REVIEW OF THE VOGTLE UNITS 1 AND 2 AUXILIARY
FEEDWATER SYSTEM RELIABILITY ANALYSIS

A. Fresco, R. Youngblood and I. A. Papazoglou

October 1984

This report is a review by Brookhaven National Laboratory (BNL) of the Vogtle Electric Generating Plant (VEGP) Final Safety Analysis Report (FSAR) Appendix 10A, entitled "VEGP Auxiliary Feedwater System Availability Analysis," prepared by Bechtel Corporation for Georgia Power Corporation.⁽³⁾

BNL Figure 6

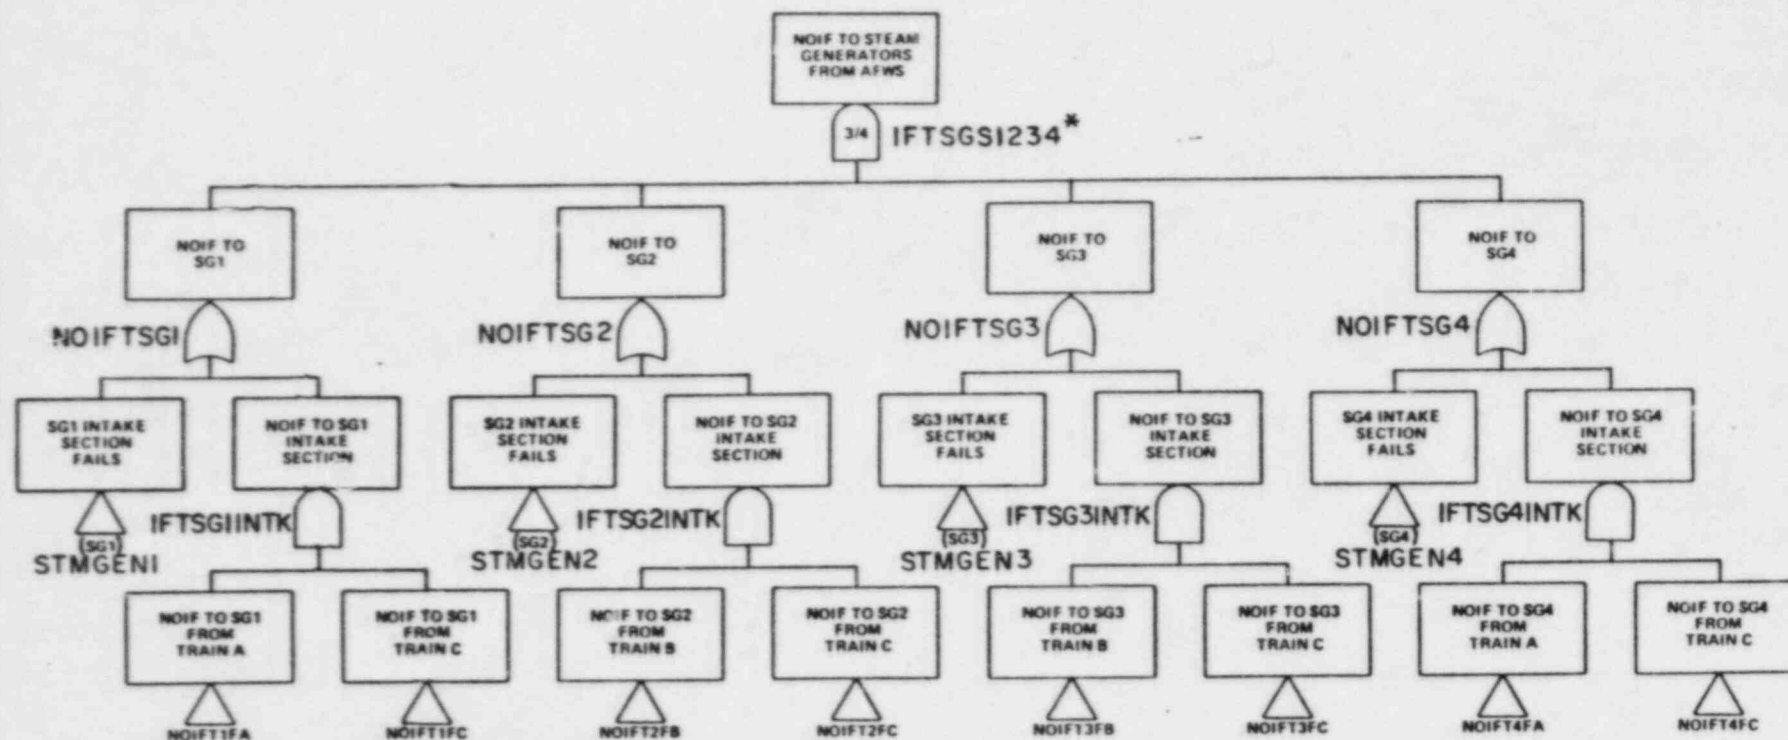
The fault trees as shown allow unrestricted coincident test and maintenance acts. Those acts which are not allowed by the Technical Specifications were then deleted from the cutsets by use of the DELETE TERM option of the SETS code. Specifically, the equation establishing the terms to be deleted is based on the Expanded Reliability Block Diagram in Figure 6, and is given below:

$$\text{DELETE} = A*B + B*C + A*C$$

BNL Figure 7 (Sheet 5 of 33)

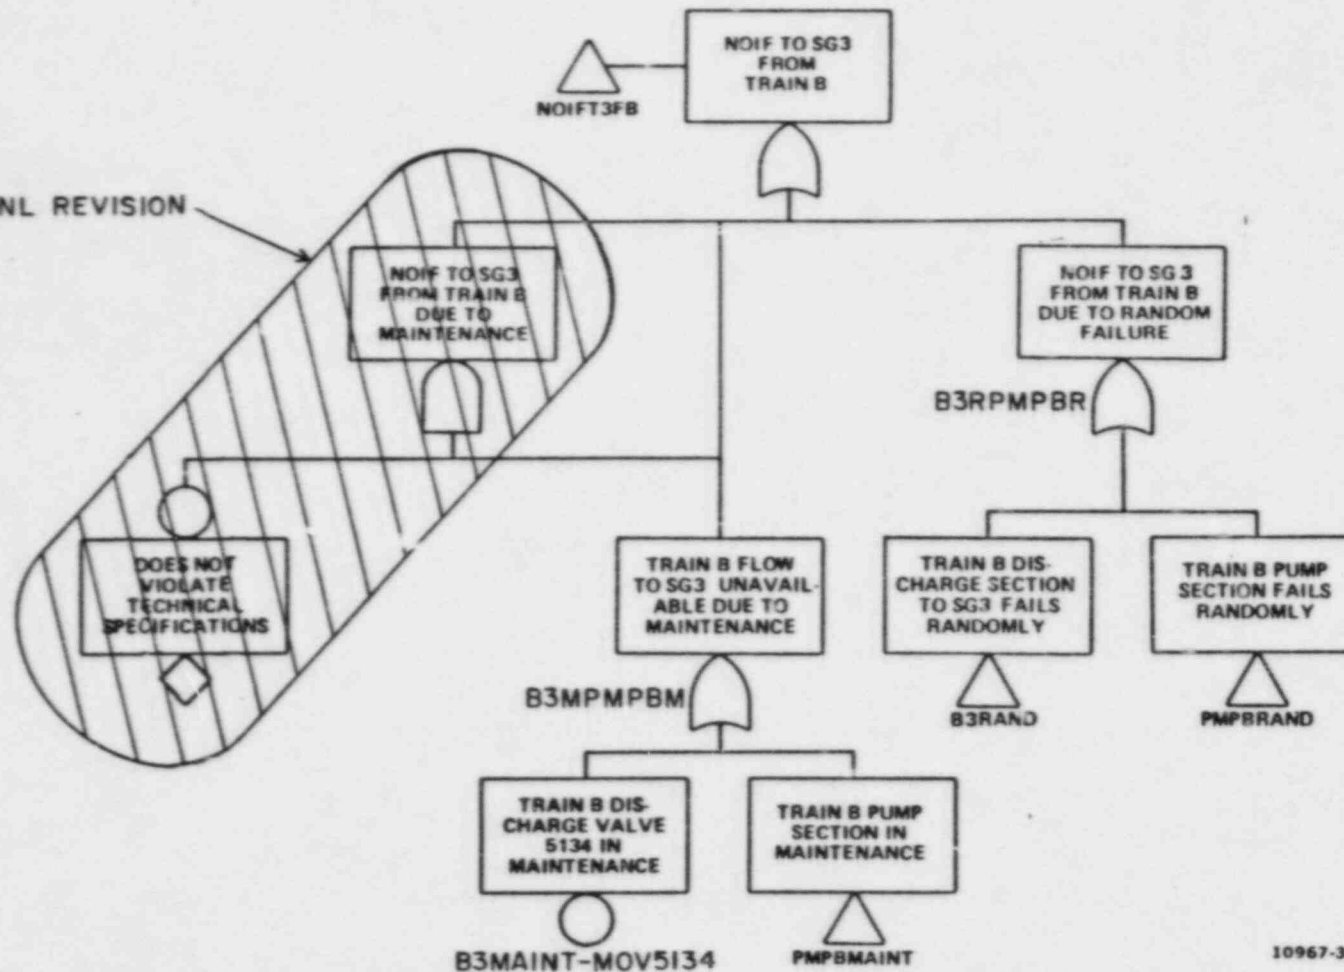
Since the applicant's fault trees, provided in Ref.3, seem to be substantially correct and complete, particularly with respect to the modeling of maintenance acts at the component level, these same fault trees with minor revisions were utilized in the BNL analysis, provided in this report as Figure 7, Sheets 1 to 33. The major revisions which were necessary were the addition of fault identifiers and a finer separation of certain maintenance acts so the top event could be properly identified and the non-functional event "Does Not Violate Technical Specifications" eliminated. The fault identification nomenclature scheme is shown in Table 6. The applicant did not separate the steam generator intake sections in the expanded block diagram, Figure 6, into random and maintenance contributors because no maintenance can be performed on either of the two check valves or the stop check valve in a typical intake section, e.g., check valves 121 and 125 and stop check valve 113 on Steam Generator 1 Intake. However, BNL did so in order to model both maintenance on

the stop check valves on the pump discharge lines to a given steam generator and also a possible unavailability due to testing if the operator fails to reclose the recirculation valve in the condensate system return line. See Figure 7, Sheets 12 and 13.

BNL Figure 7 (Sheet 28 of 33)
UNIT 1 AFWS FAULT TREE MODEL
FSAR

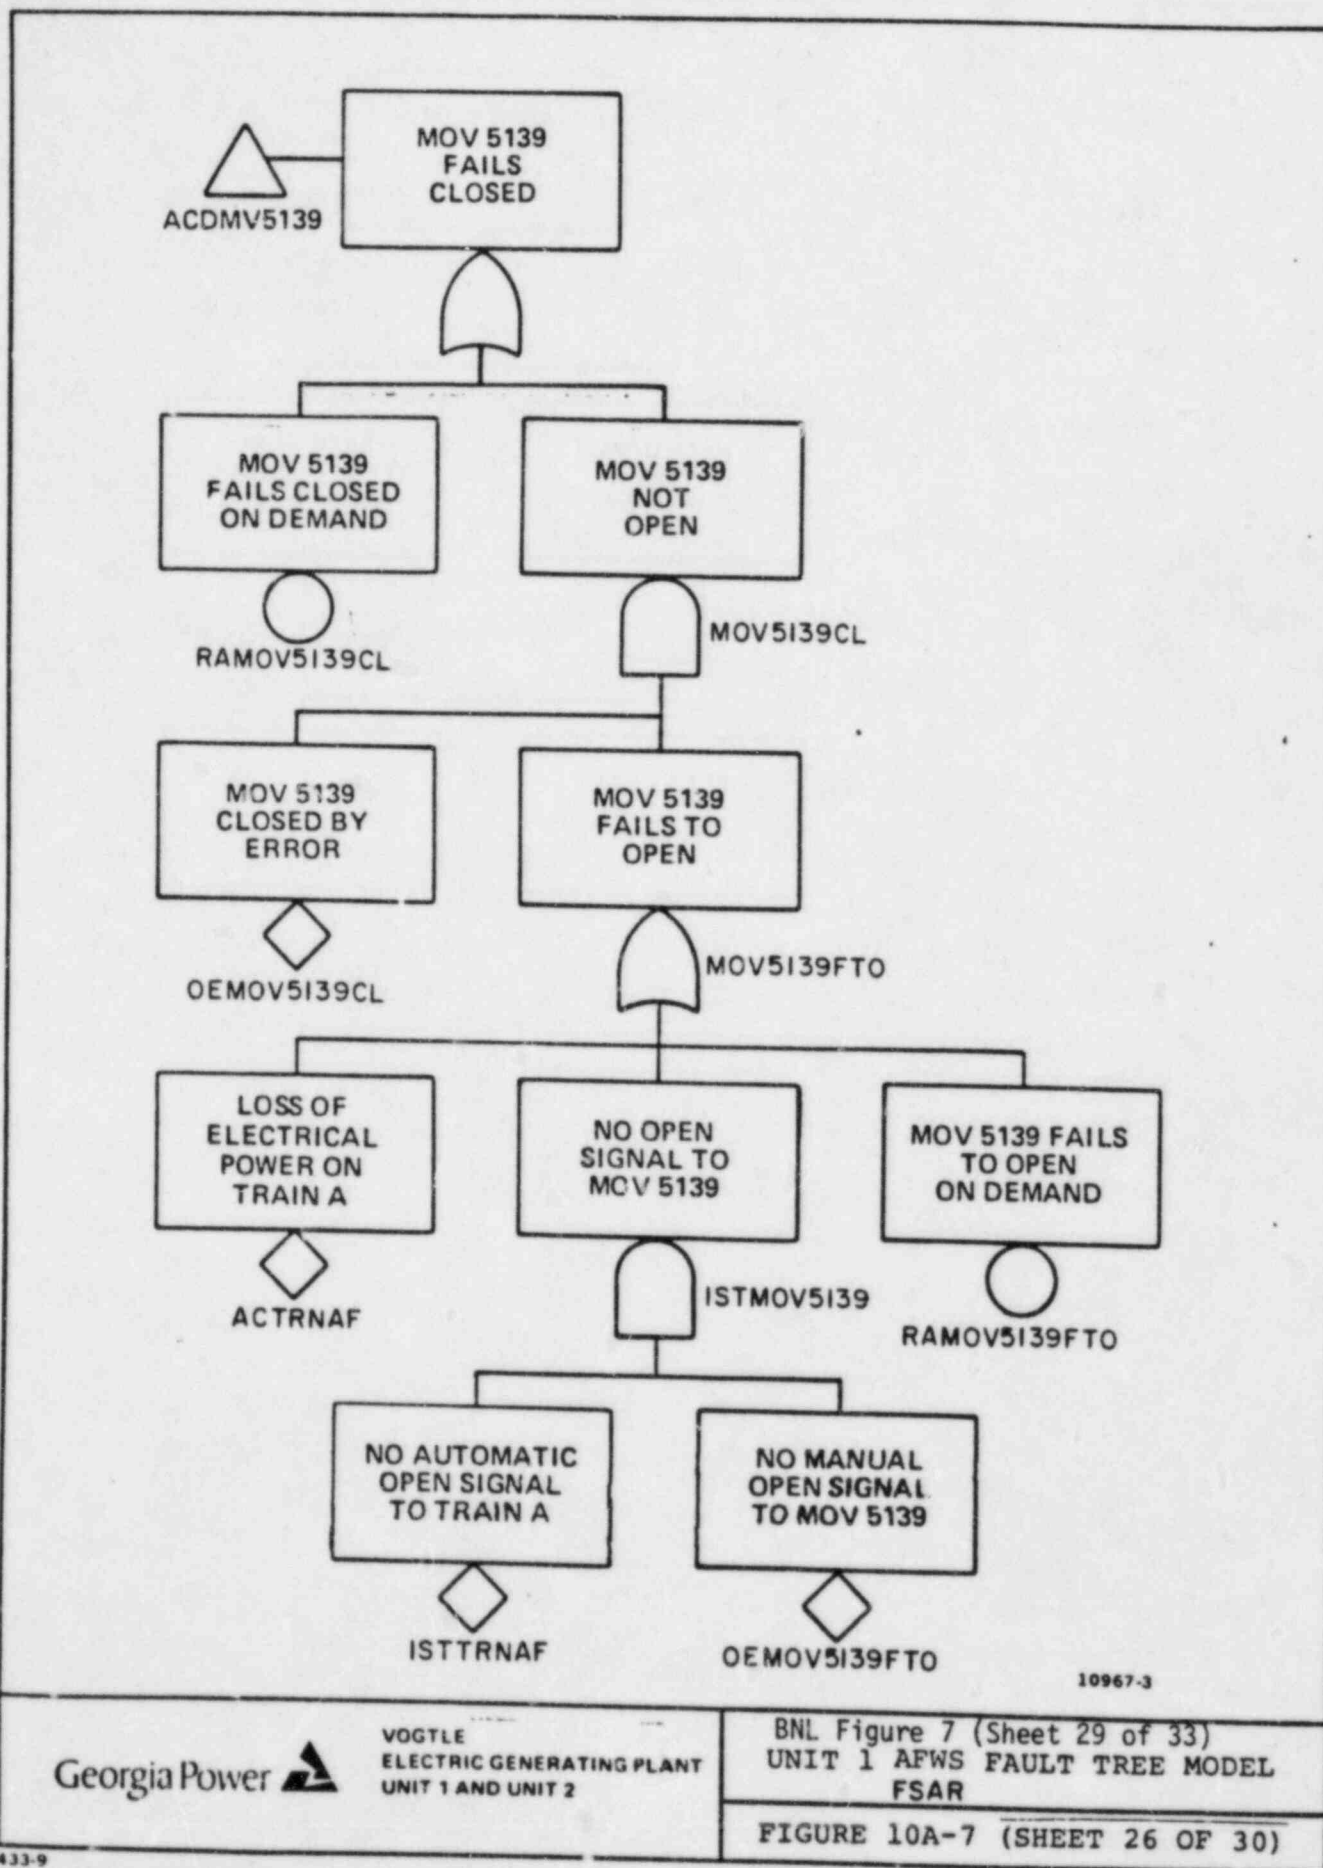
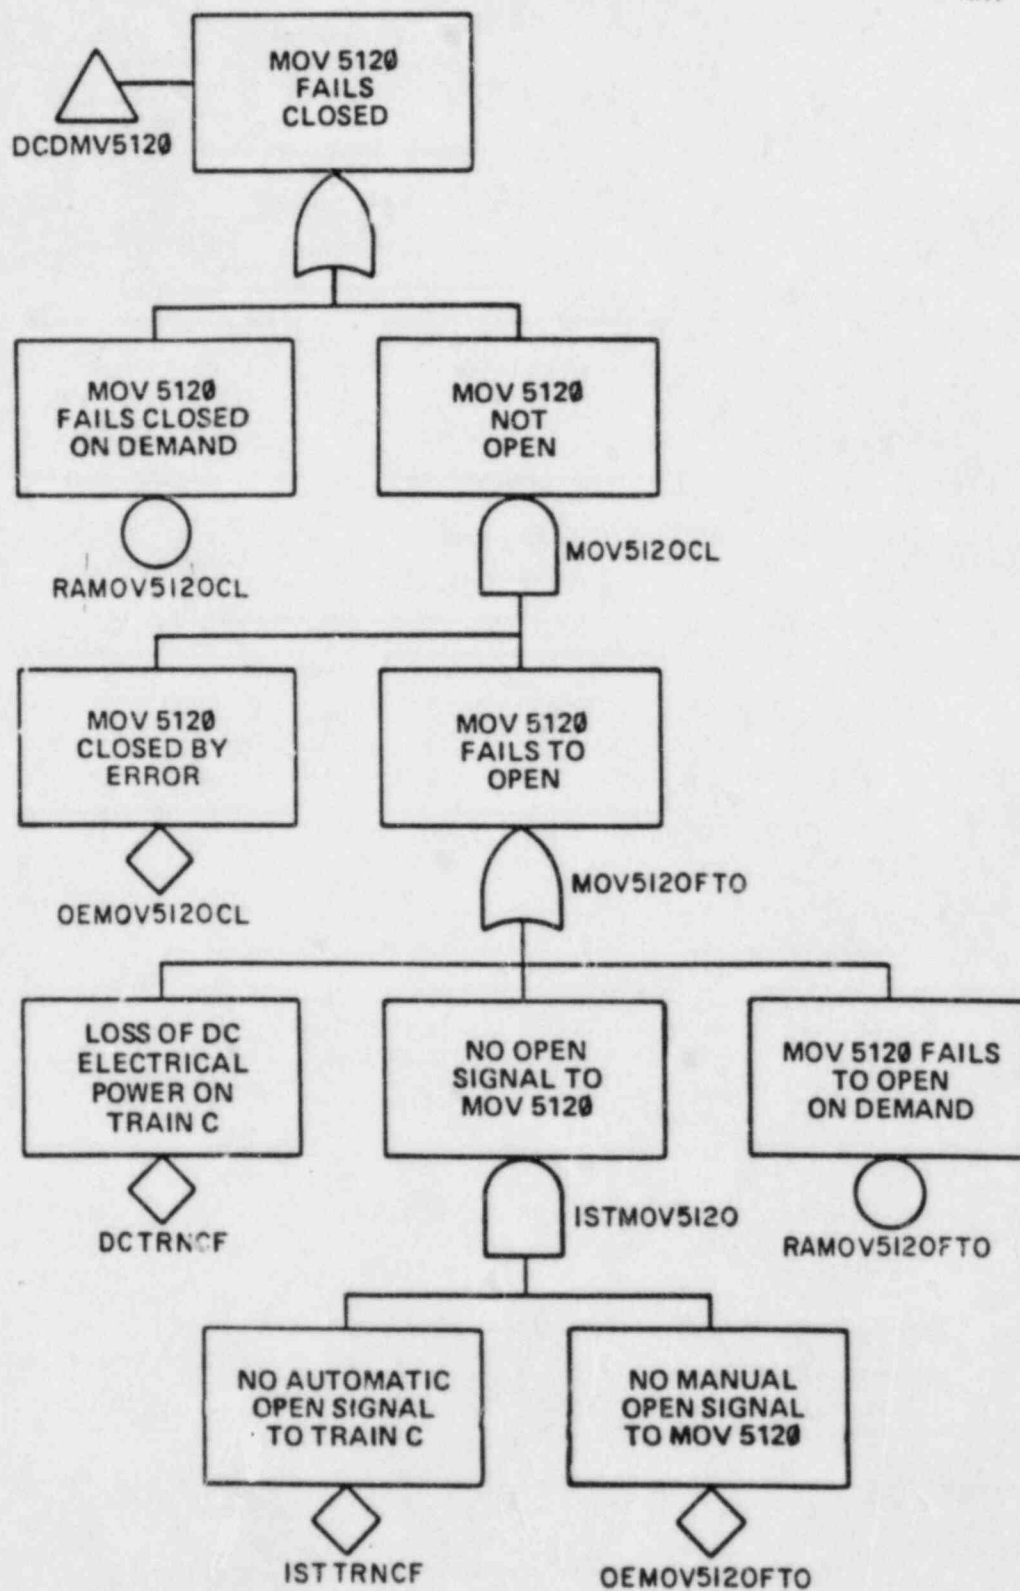
In addition, the fault tree does not model maintenance acts excluded by technical specification requirements in any useful way, particularly considering that the applicant utilized in WAM-CUT(7) computer code. Specifically, in Figure 10A-7, Sheets 2 through 9 (BNL Figure 7, Sheets 3 through 10), show that the inputs to the AND gates : "NOIF TO SG__ FROM TRAIN __ DUE TO MAINTENANCE" and a NOT gate described as "DOES NOT VIOLATE TECHNICAL SPECIFICATIONS".
